Reply to the reviewer comments RC2: 'modelling of hydrology and nitrate export from catchment' by Anonymous Referee #2

Figure caption:

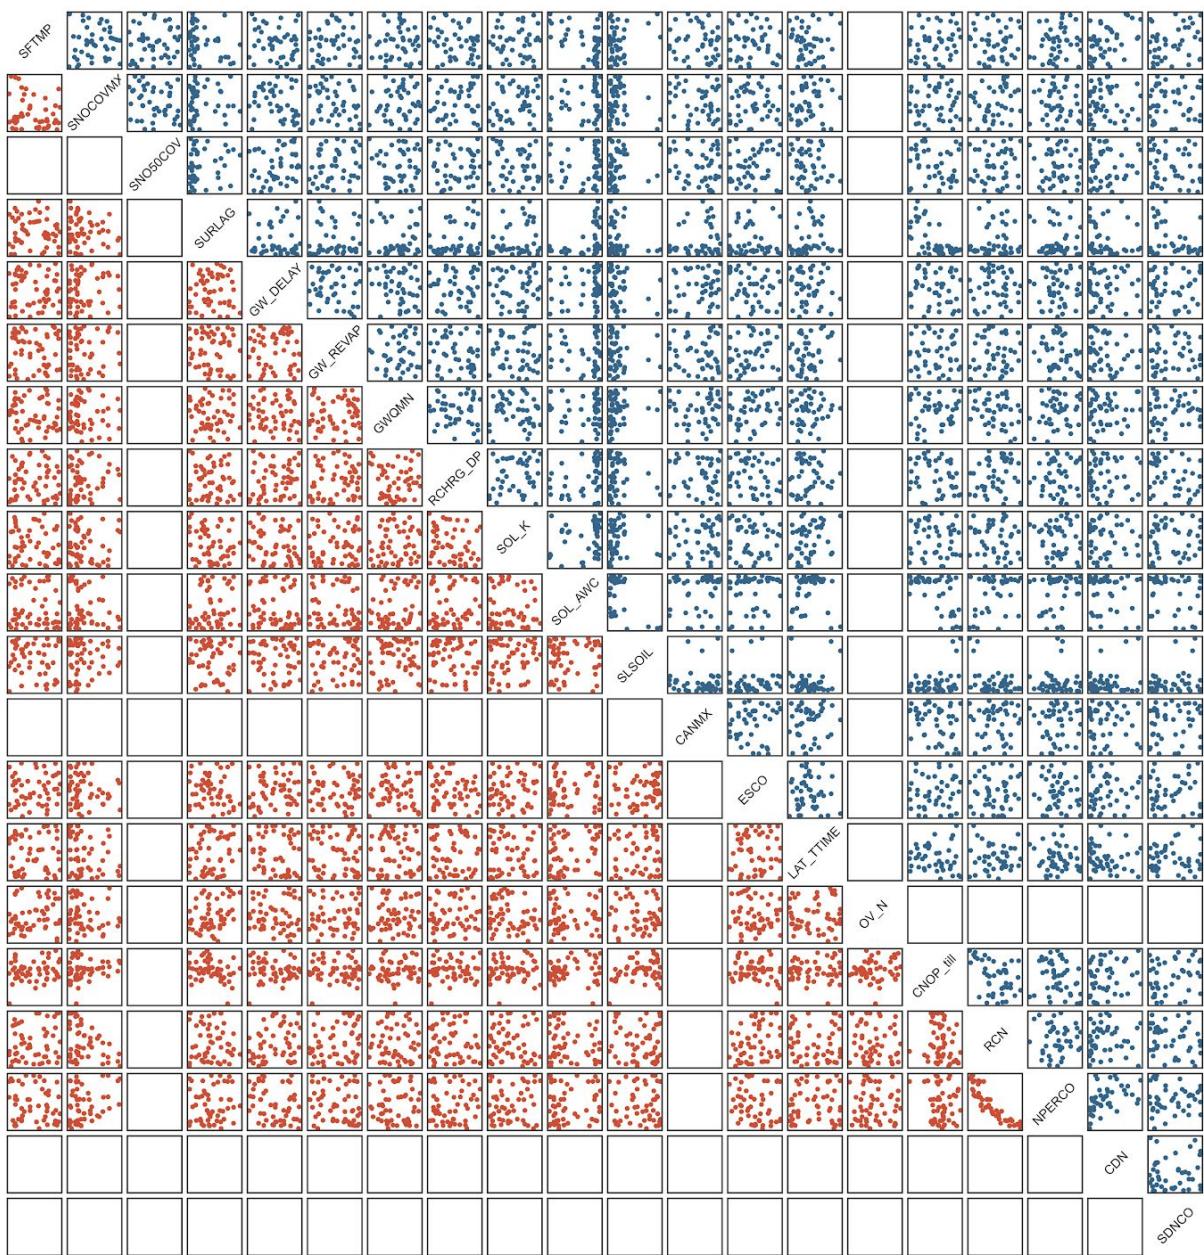
From my view, more credibility can be given to the parametrization of model (which shows very high impact to simulated results and uncertainty) when the selected parameter values that were used in the uncertainty analysis are given, at least in the Appendix.

Based on this comment and comments made by other reviewers, we propose to add the following information to provide further detail on the model parameters used.

To show a clustering of model parameter values of the selected parameters and to identify parameter interactions we add the following figure in the Appendix of the manuscript:

Coordinate plot of the 43 and 52 behavioral SWAT model parameters that were used with the model setups of the Schwechat and the Raab, respectively. Each panel illustrates the connection of two model parameters for the Schwechat in red (below the diagonal) and the Raab in blue (above the diagonal). The x and y axes of each panel show the range of the respective parameter plotted along the x or y dimension. The corresponding parameter ranges for all illustrated parameters are provided in Table XX (Reference to table below).

Due to the limited space in the figure we avoided plotting axes and axis labels. The figure however illustrates the clustering and interaction of model parameters. We additionally suggest to add parameter ranges and the type of change of the model parameters in an additional table:
